**SITE PLAN REVIEW SHEET
ENVIRONMENTAL VARIANCE REQUEST ONLY**

CASE: SP-2017-0146D

PROJECT NAME: 4213 Watersedge Cove

ENVIRONMENTAL COMMISSION VARIANCE APPLICATION FORM

PHOTO OF THE BULKHEAD

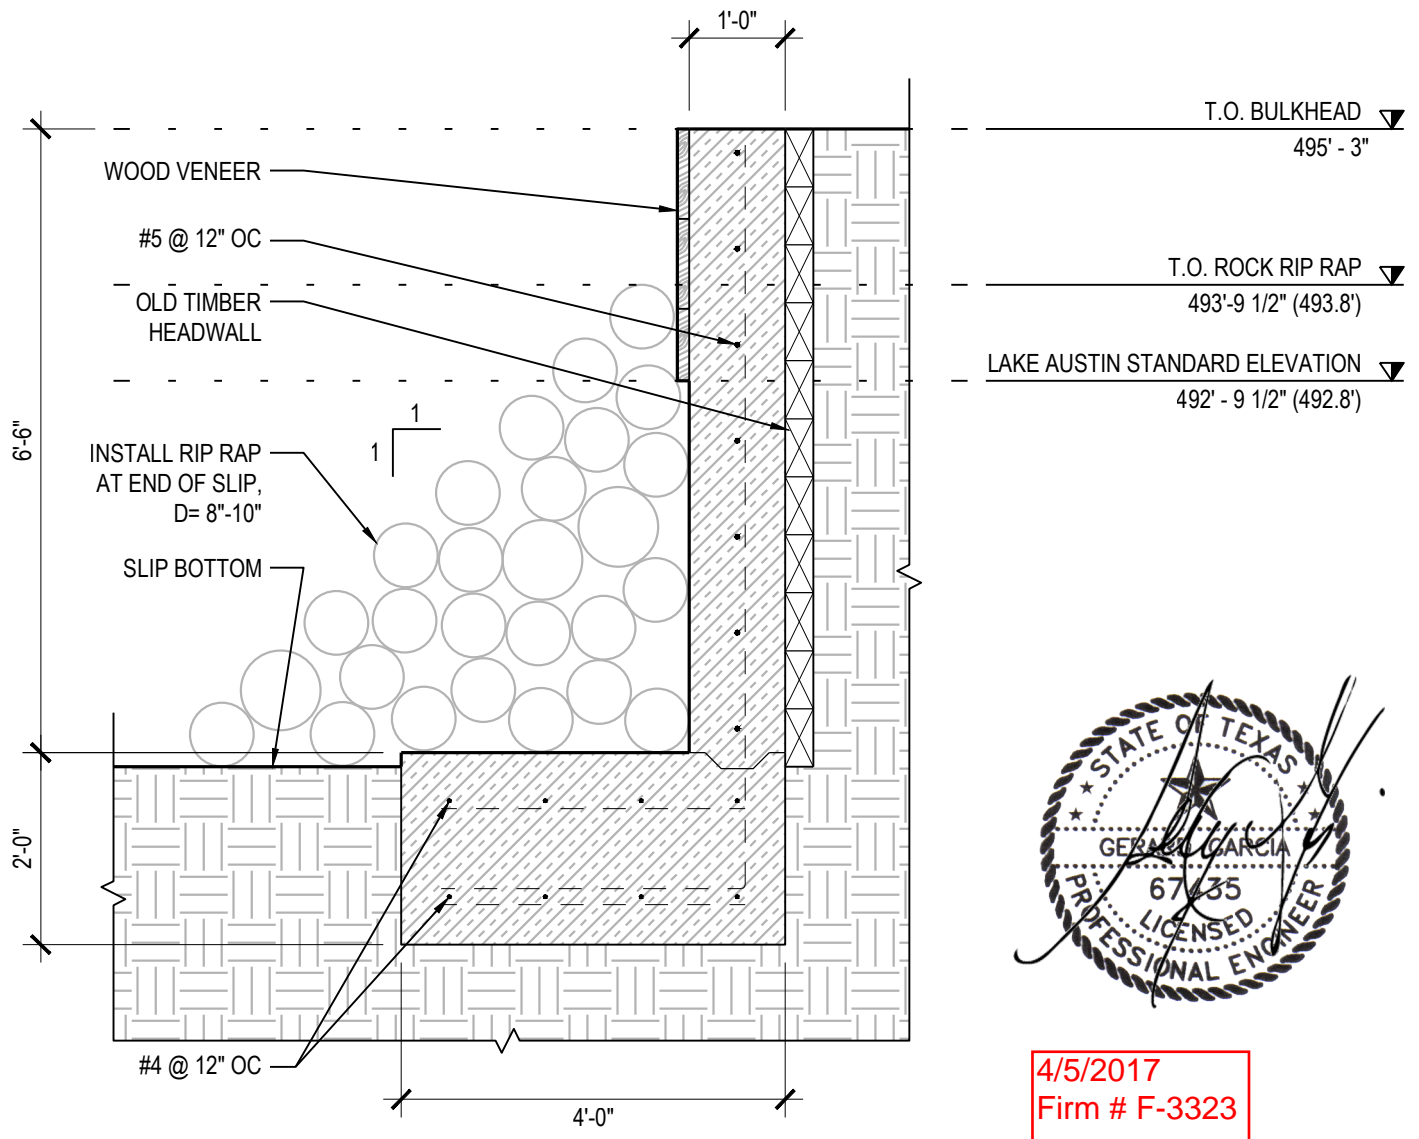
Clearly indicate in what way the proposed project does not comply with current Code (include maps and exhibits)	<i>In order to repair a failing bulkhead within an existing cut-in slip, a new concrete bulkhead was installed in front of the failing bulkhead while the lake was down. The shoreline was located at the face of the failing bulkhead. The new bulkhead is 12" thick. The allowable width of a replacement bulkhead constructed lakeside of the shoreline is 6". The new bulkhead is 6" too thick within the cut-in slip.</i>
---	--
